**MUNICIPAL PLANNING COMMISSION
THURSDAY JULY 7, 2016 – 12:00 PM
TOWN OF REDCLIFF**

| | A) Development Permit Application 16-DP-031

Saleh & Tammy Gader
Lot 63, Block 138, Plan 0813500 (409 1 Street NE)
Semi-Detached Dwelling |

Development Permit Application **Background Information / Review**

409 1st St NE.

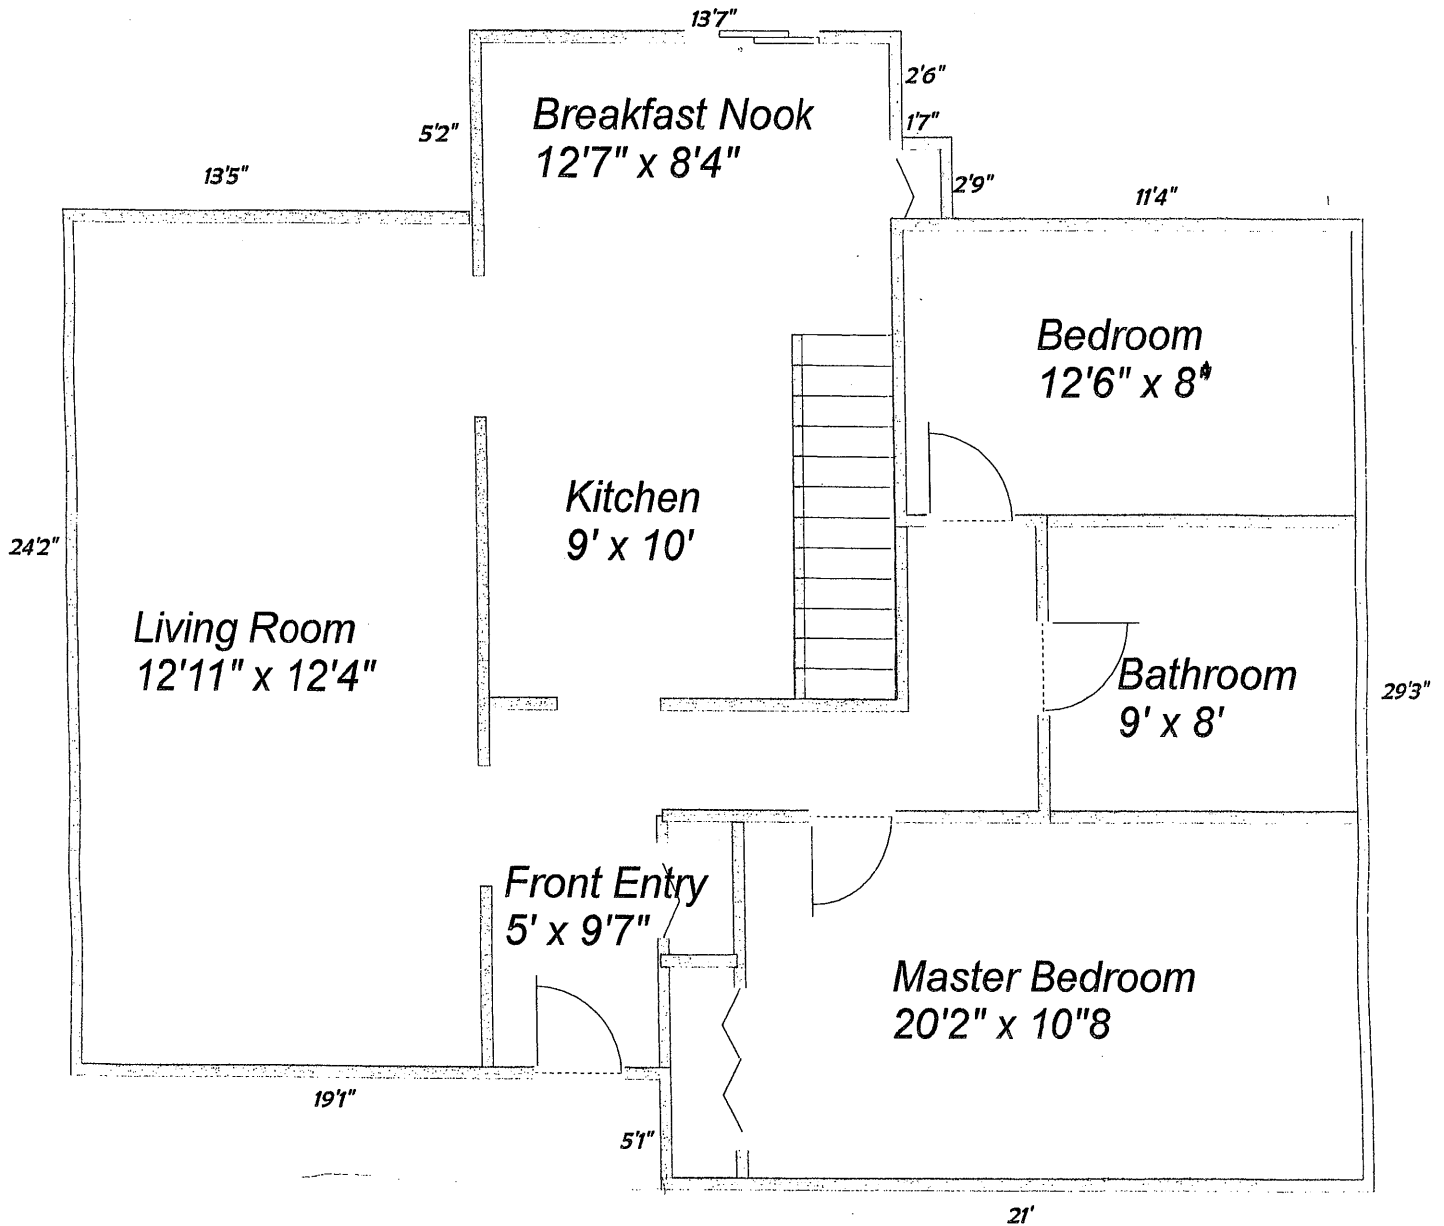
- The site plan shows only one (1) parking stall, the Land Use Bylaw requires two (2) parking stalls for a single detached dwelling;
- The site plan shows a parking stall size of 3.023 m by 6.0 m. The identified parking stall does not meet the Land Use Bylaw requirement of a parking stall to be 2.7 m by 7.3 m;

- The Applicant has provided a drainage plan that is acceptable to the Director of Planning & Engineering.
- The site plan shows the assumed front of home is facing the neighbour's back yard (see attached pictures).

- c. A plan showing 2 parking stalls that meet or exceed the Town of Redcliff's Land Use Bylaw requirements. The plan is to be satisfaction of the Development Officer;

- b. A plan showing 2 parking stalls that meet or exceed the Town of Redcliff's Land Use Bylaw requirements. The plan is to be satisfaction of the Development Officer;
